Preservation Department – Item 1, LPC-22-08731

**6301 12th Avenue, aka 6301-6323 12th Avenue, 1202-1216 63rd
Street, and 1201-1215 64th Street – Angel Guardian Home –
Individual Landmark
Borough of Brooklyn**

LPC-22-08731: 6301 12th Avenue, Angel Guardian Home - Individual Landmark

PUBLIC MEETING SCOPE 09/20/2022

PROPOSED AND REVISED SITE PLAN:

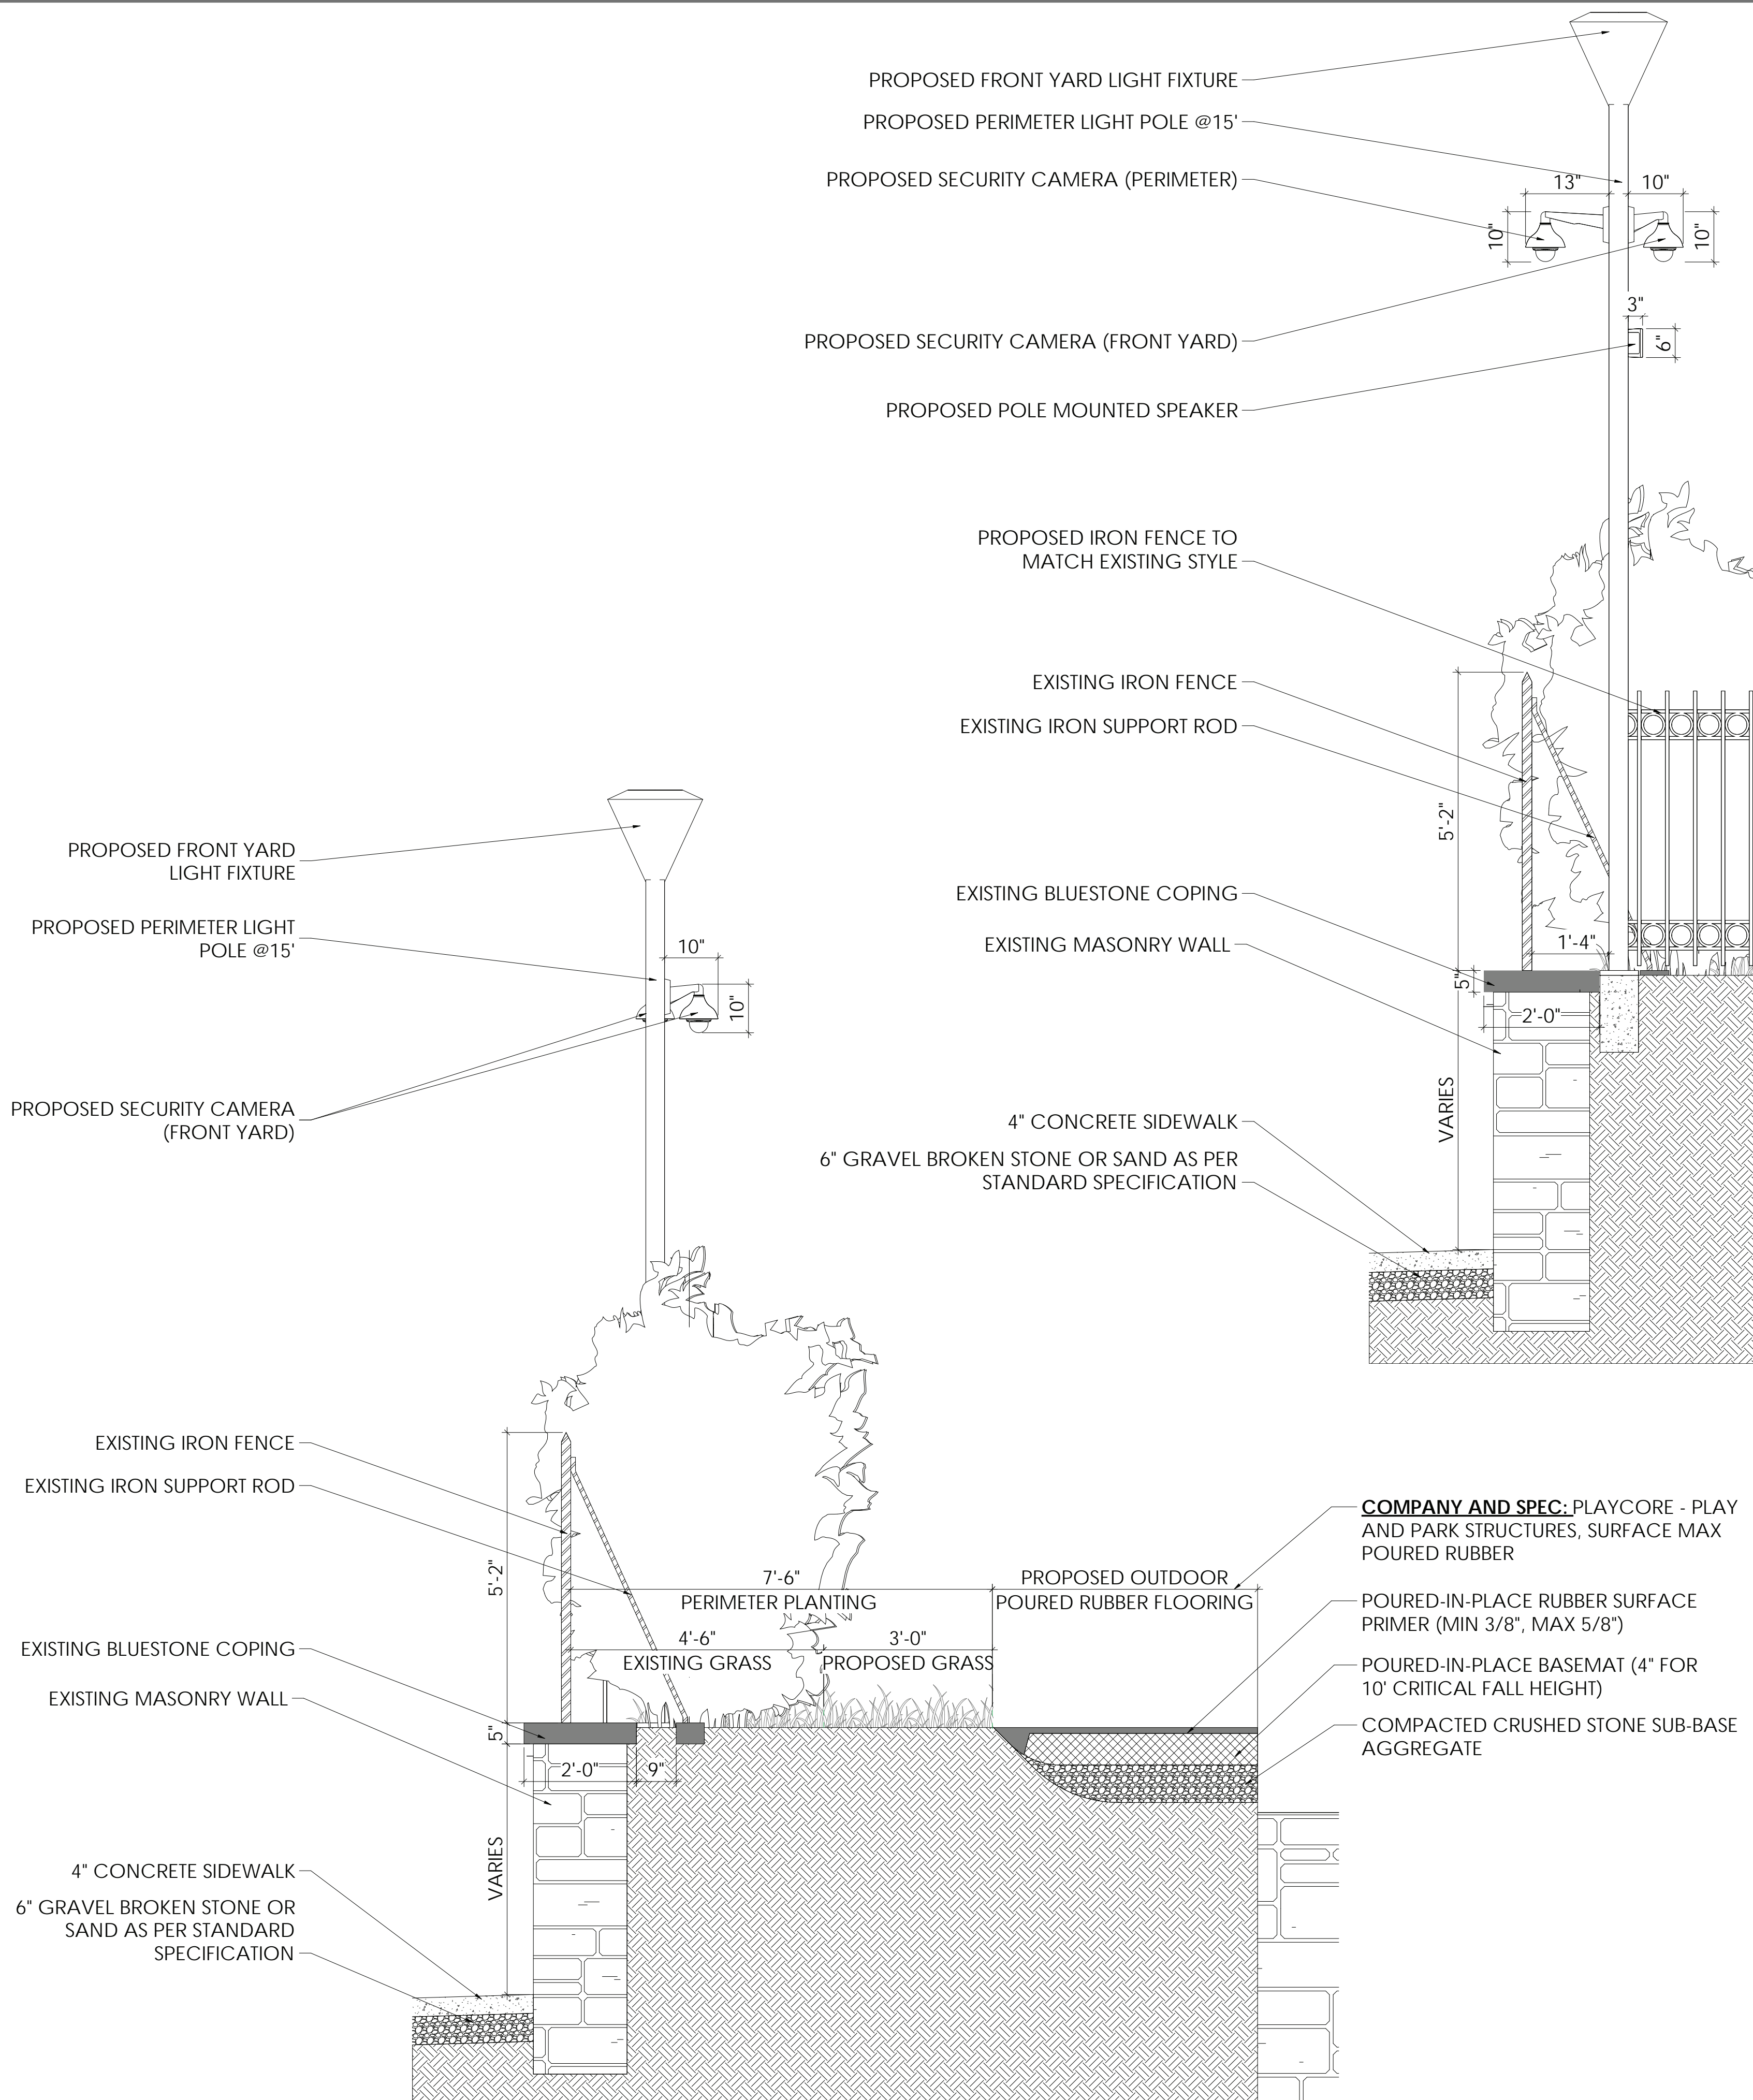
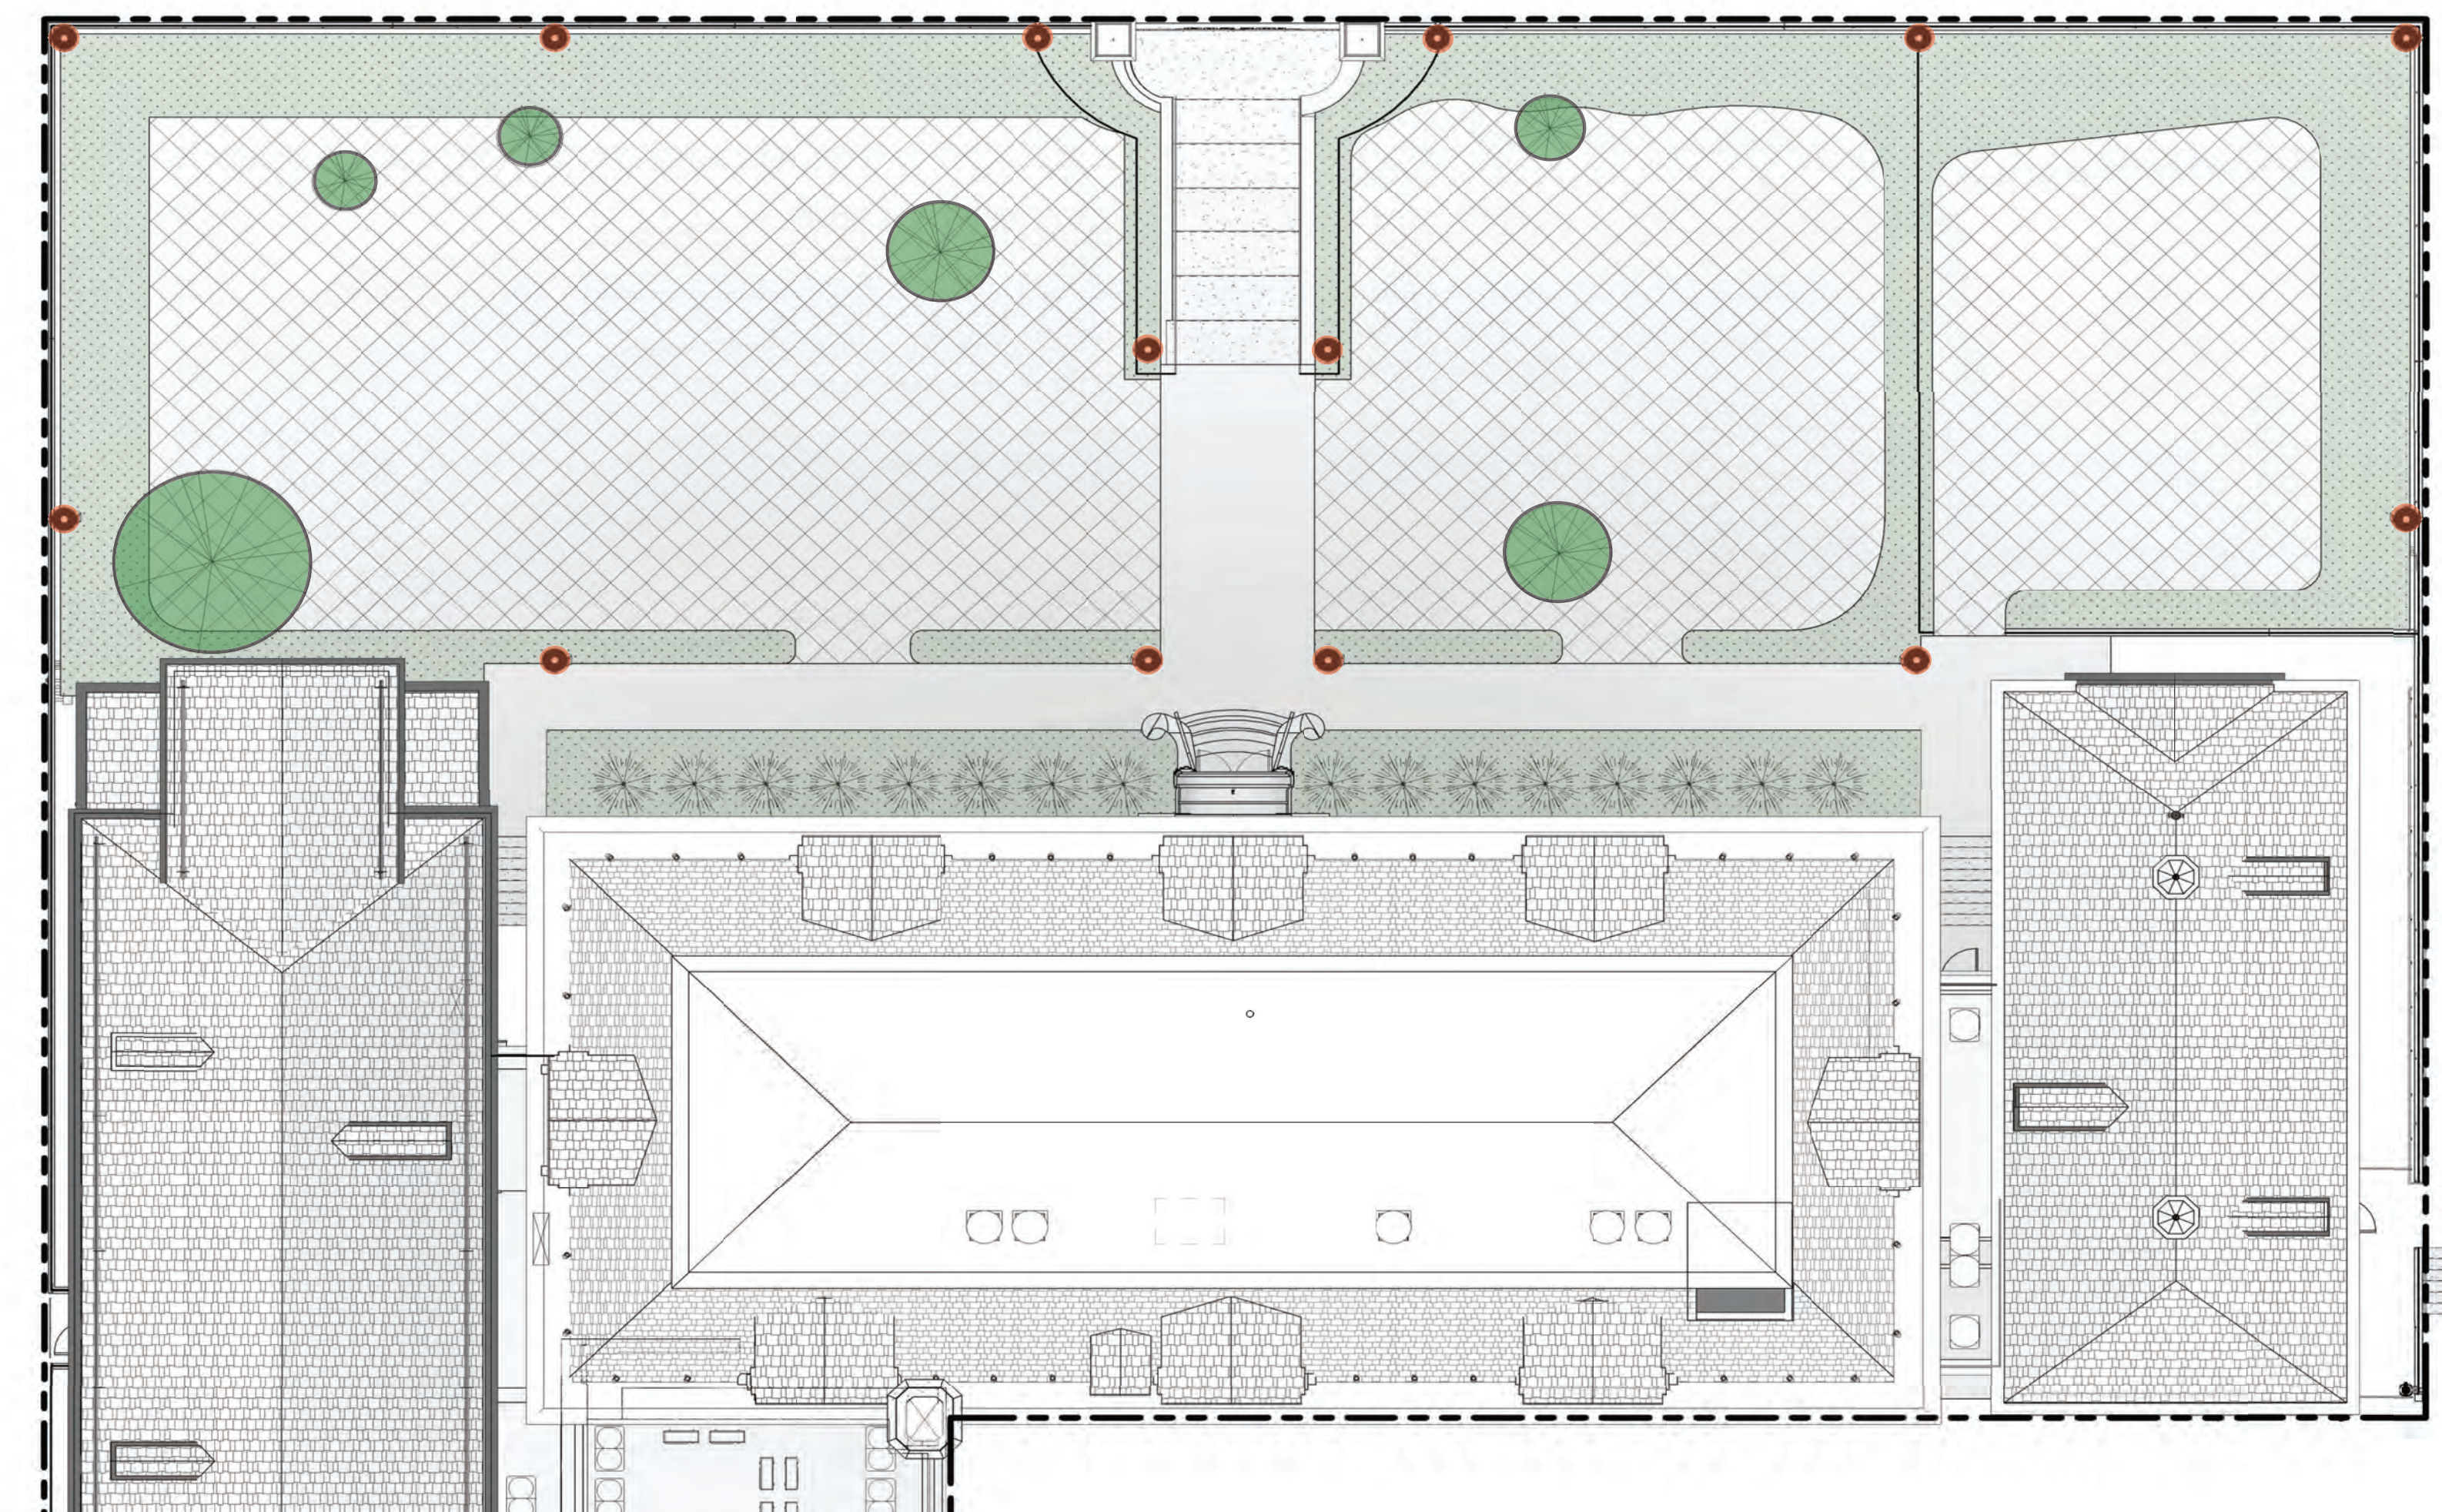
- TREE IN FRONT OF 63RD ST WING TO BE REMOVED
- ADDITIONAL TREES ADDED
- REVISED LIGHT POLE PLACEMENT (LESS POLES, MORE SPACED OUT)
- MAIN BUILDING FACADE LETTERING SHORTENED
- LETTERING ON ARCH REMOVED
